Planning and Development Services Division Issues Report

Petition: **P.Z. 05-2016 Wildhorse Baxter Center, C148B (Shelbourne Senior Living):**
A request for a zoning map amendment from a “C-8” Planned Commercial District to a “UC” Urban Core District for 5.21 acres located south of Wild Horse Creek Road and east of its intersection with Baxter Road (18T630283).

RE: PZ 05-2016 Wild Horse Baxter Center, C148B (Shelbourne Senior Living)

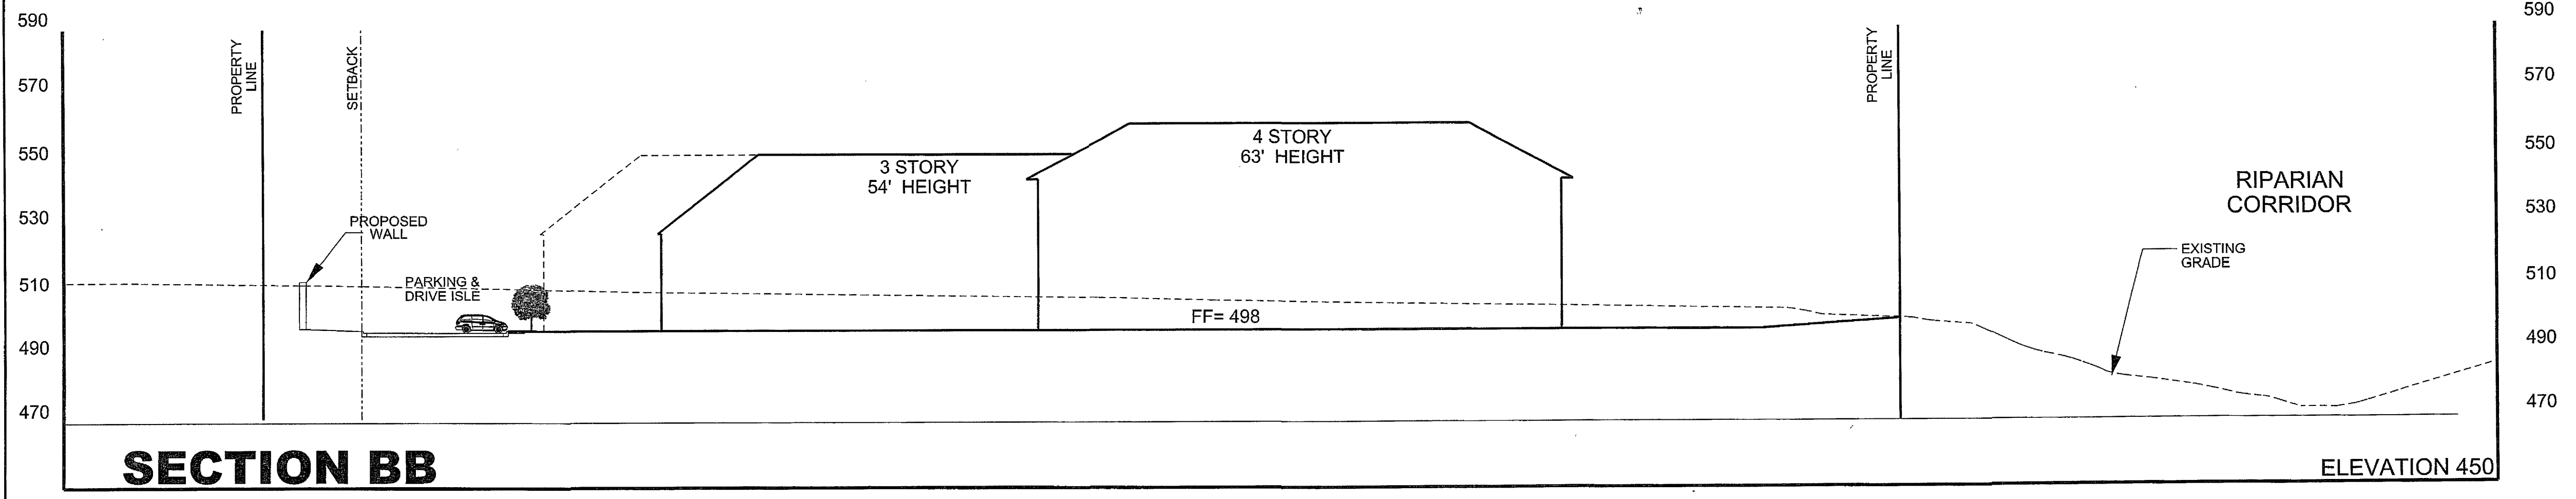
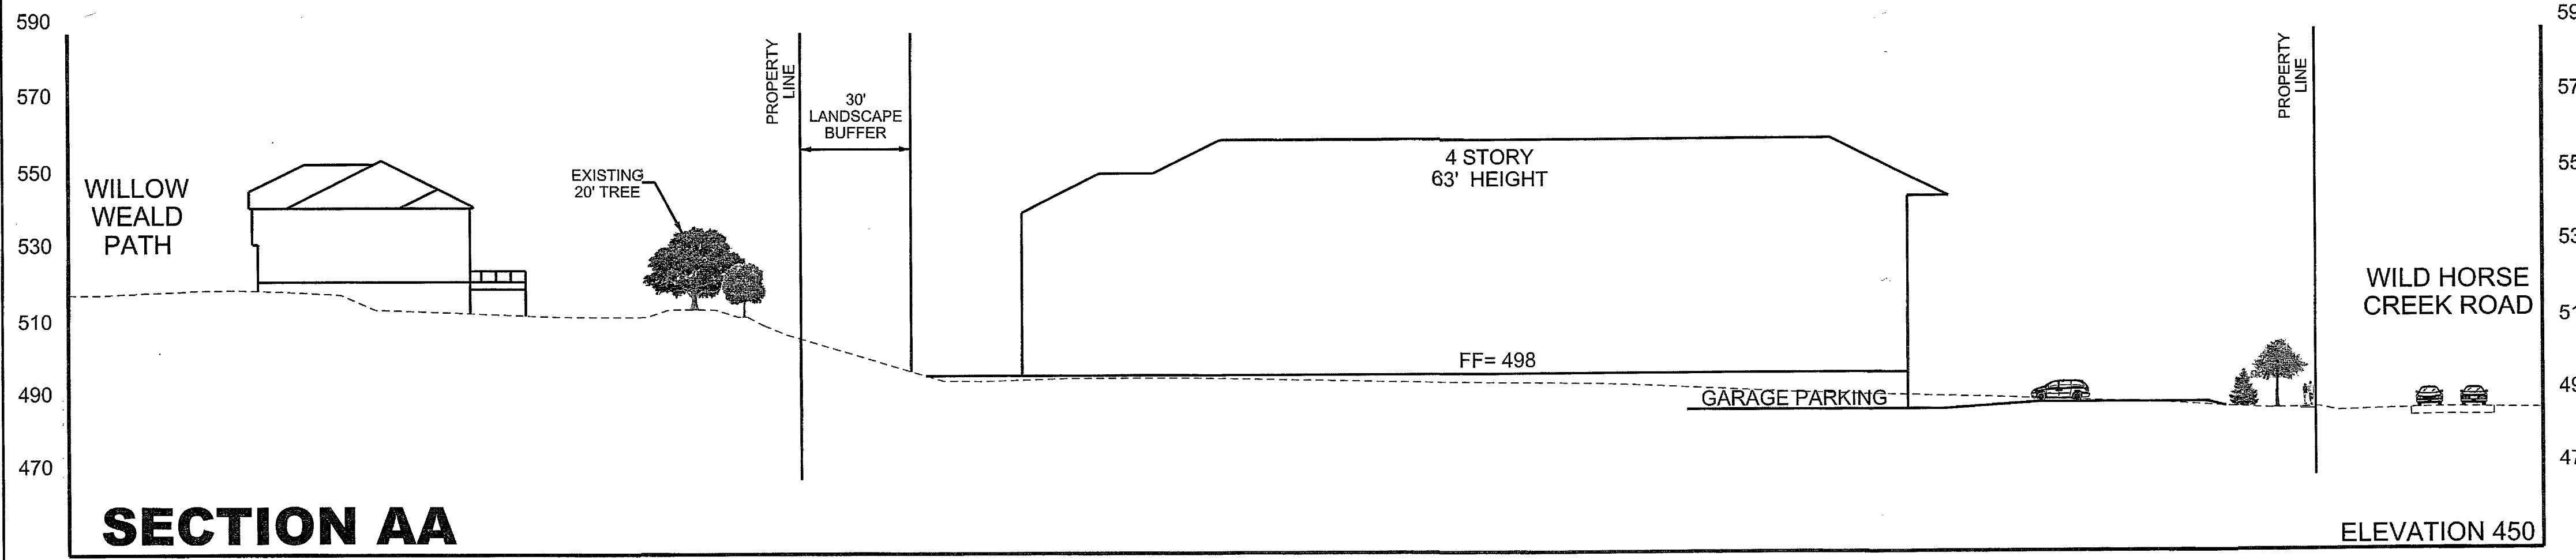
4. *Provide sight-line exhibits or similar methods to illustrate the visual impact when looking toward the proposed development from within the Reserve at Chesterfield Village.*

7. Review and revise the horizontal scale on Sections AA and BB. There are several distances on the cross sections that do not match the distances on the plan view. As examples, the following distances are depicted incorrectly:

- a. Between the west property line and the proposed wall,
- b. Between the south property line and the proposed building, and
- c. Between the north property line and the proposed roadway pavement.

The Petitioner has provided the requested section profiles. These profiles show the line of sight from two properties located within the Reserve at Chesterfield Village, as requested. A sight line is provided for each area of the proposed structure to illustrate the impact of both the 3-story section of the proposal and the 4-story section. The site lines illustrate that the proposed structures would not significantly block light from the subject sites. The site lines also provide a depiction of the scale of the building massing between the residential structures and the proposed senior living facility on the subject site.

See revised plan.
